**Re: Coors Blvd. – Tucson Rd. Retail Shops
Coors Blvd. and Tucson Rd.
Traffic Circulation Layout
Engineer's/Architect's Stamp 3-10-16 (G11-D031)**

Based upon the information provided in your submittal received ~~XX-XX-16~~ ³⁻¹¹⁻¹⁶, the above referenced plan cannot be approved for Building Permit until the following comments are addressed:

TRAFFIC CIRCULATION LAYOUT PLAN

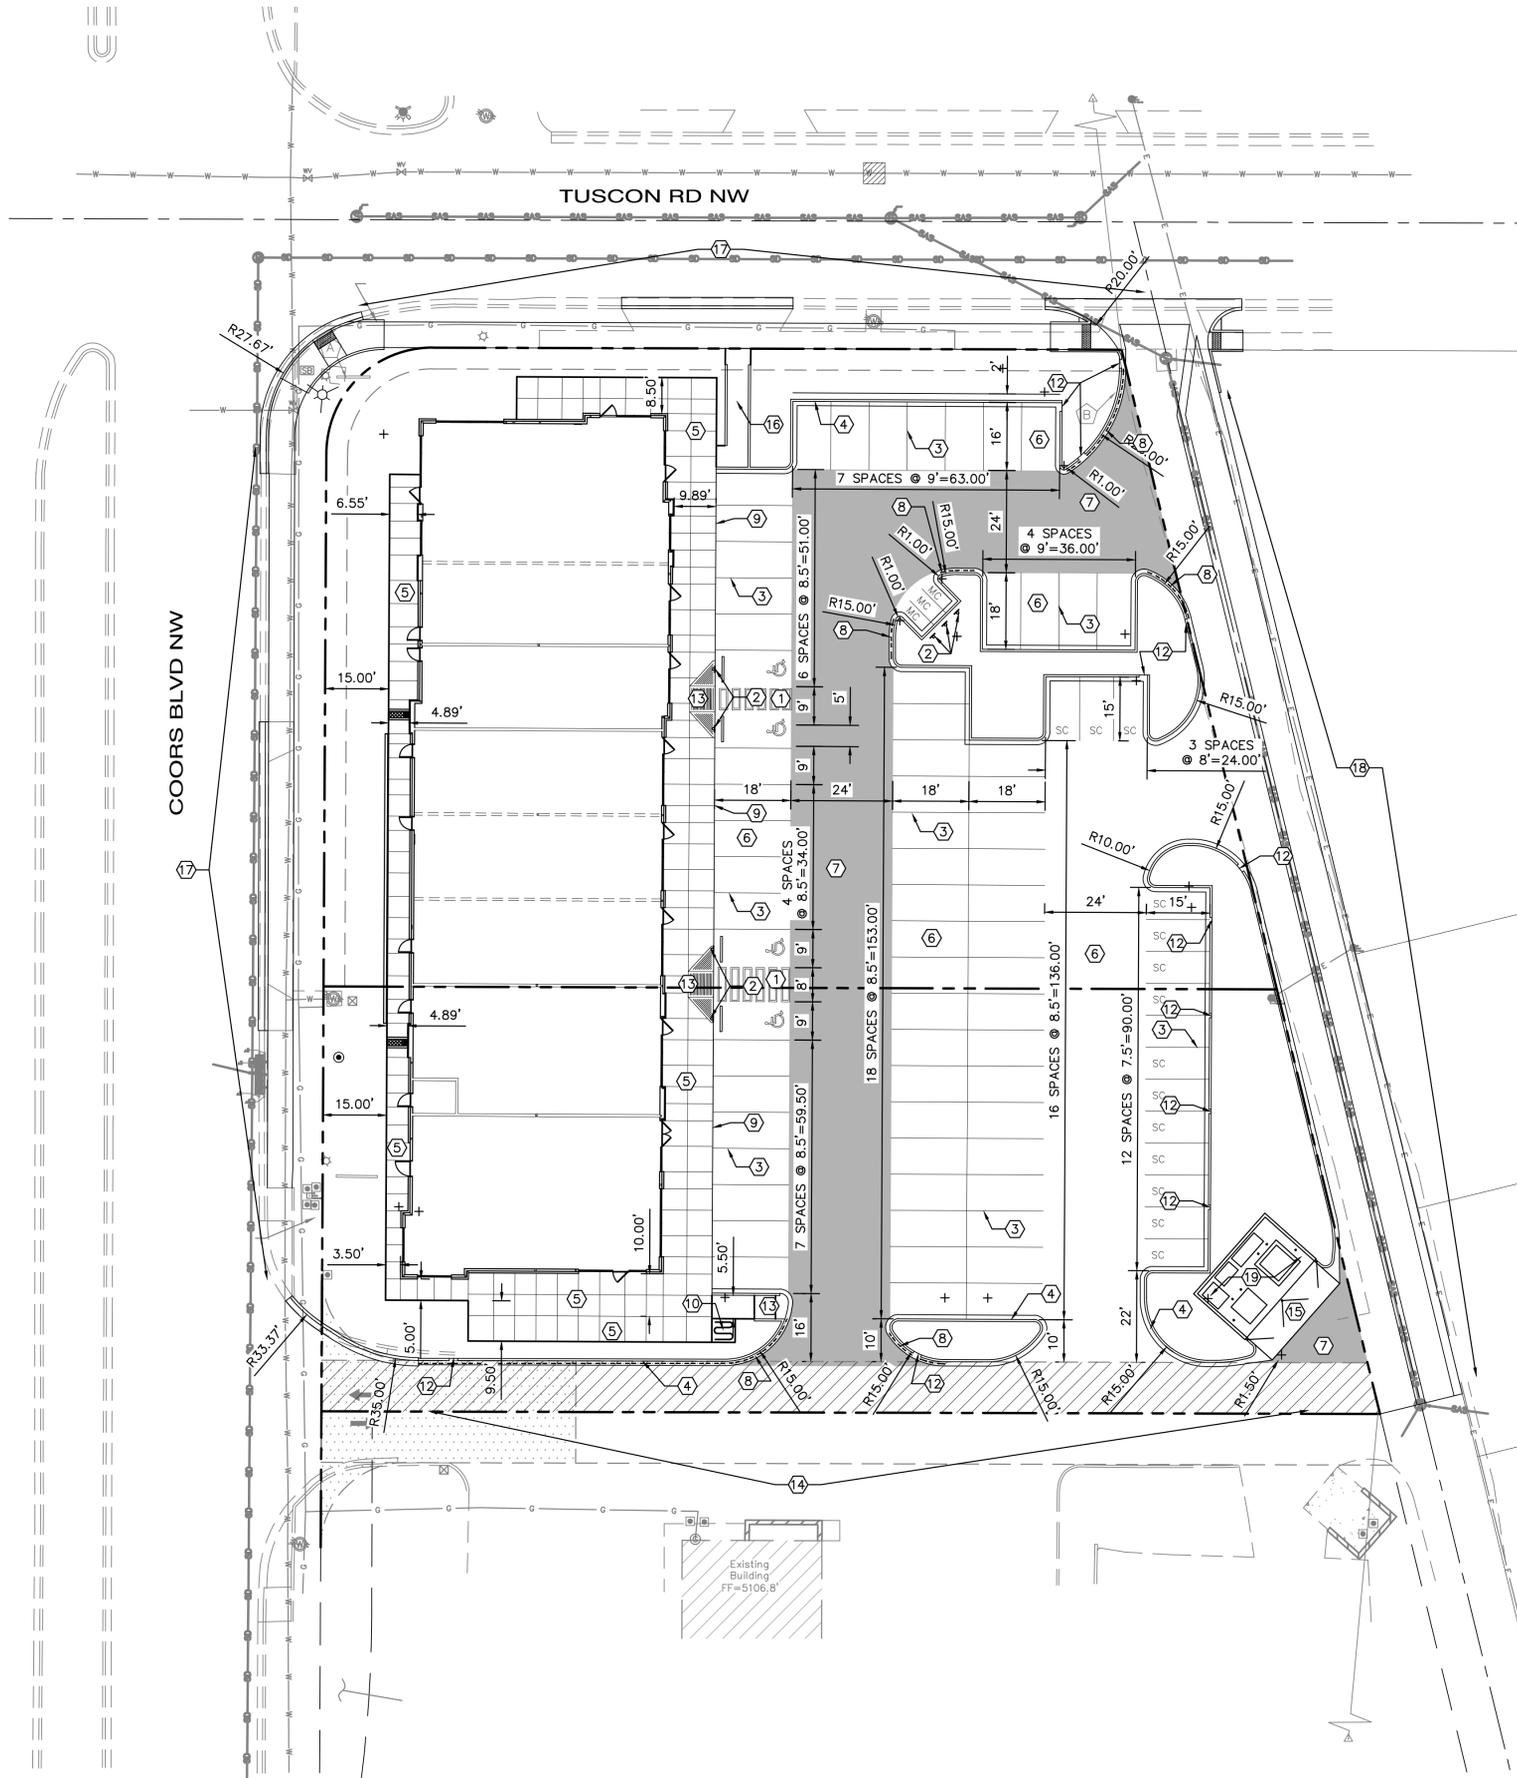
1. Clarify the extents of the current phase.
2. Please identify all existing buildings, doors, structures, sidewalks, curbs, drive pads, wall and anything that influences the parking and circulation on the site.

3. Please detail and dimension all proposed sidewalks, curb cuts, ADA ramps and intersection details. Please show all traffic directional arrows and signs.

4. Identify all existing access easements and rights of way with dimensions.
5. Identify the right of way width, medians, curb cuts, and street widths on Coors Blvd. and Tucson Rd., public alley and shared entrance south of the project site on Coors Blvd.

6. Please list the width and length for all existing and proposed parking spaces.
7. Compact parking spaces are defined and dimensioned as 8 ft. wide by 15 ft. in length. In review of submitted drawing, the parking spaces at the south east corner at 7.5 ft. wide.

8. Label the compact parking spaces by placing the words "**COMPACT**" on the pavement of each space.
9. The handicap accessible spaces must be a minimum of 8.5 ft. in width.

10. The handicap accessible spaces must include an 8 ft. wide van access aisle; all other aisles should be 5 ft. in width. Please clarify and detail the dimension of HC parking spaces.

11. The ADA accessible parking sign must have the required language per 66-7-352.4C NMSA 1978 "**Violators Are Subject to a Fine and/or Towing.**" Please call out detail and location of HC signs. Please show a detail of HC parking signs.

12. The ADA access aisles shall have the words **"NO PARKING"** in capital letters, each of which shall be at least one foot high and at least two inches wide, placed at the rear of the parking space so as to be close to where an adjacent vehicle's rear tire would be placed. (66-1-4.1.B NMSA 1978) Please show this detail.

13. Show all drive aisle widths and radii.
14. Per DPM, a 6 ft. wide ADA accessible pedestrian pathway is required from the public sidewalk to the building entrances. Please clearly show this pathway and provide details from Coors Blvd. and Tucson Rd.

15. Per DPM, a 6 ft. wide ADA accessible pedestrian pathway is required from the HC parking stall access aisles to the building entrances. Please clearly show this pathway and provide details of pathway and HC ramps.

16. Provide a min 6" or max 8" high concrete barrier curb or other acceptable barrier between landscaping and parking areas and/or drive aisles. Please call out detail and location of barrier curb. Please call out detail and dimension of curb barrier.

17. Design delivery vehicle route needs to be shown.
18. Service vehicle and/or refuse vehicle maneuvering must be contained on-site; provide a copy of refuse approval.

19. Please provide a sight distance exhibit (see the *Development Process Manual, Chapter 23, Section 3, Part D.5 Intersection Sight Distance*). Please call out this detail for the intersection of Coors Blvd. and Tucson Rd. Provide a clear sight details for all entrances and exits off of Coors Blvd. and Tucson Rd. per DPM requirements for residential roads and alley ways.

20. Please add the following note to the clear sight triangle: "Landscaping and signage will not interfere with clear sight requirements. Therefore, signs, walls, trees, and shrubbery between 3 and 8 feet tall (as measured from the gutter pan) will not be acceptable in this area."
21. Please include a copy of your shared access agreement with the adjacent property owner.

22. See Chapter 23, Section 6 of the City of Albuquerque *Development Process Manual*, for appropriate drive pad widths.
23. Unused curb cuts must be replaced with sidewalk and curb & gutter. A build note must be provided referring to the appropriate City Standard drawing.
24. All broken or cracked sidewalk must be replaced with sidewalk and curb & gutter. A build note must be provided referring to the appropriate City Standard drawing.
25. Please include two copies of the traffic circulation layout at the next submittal.
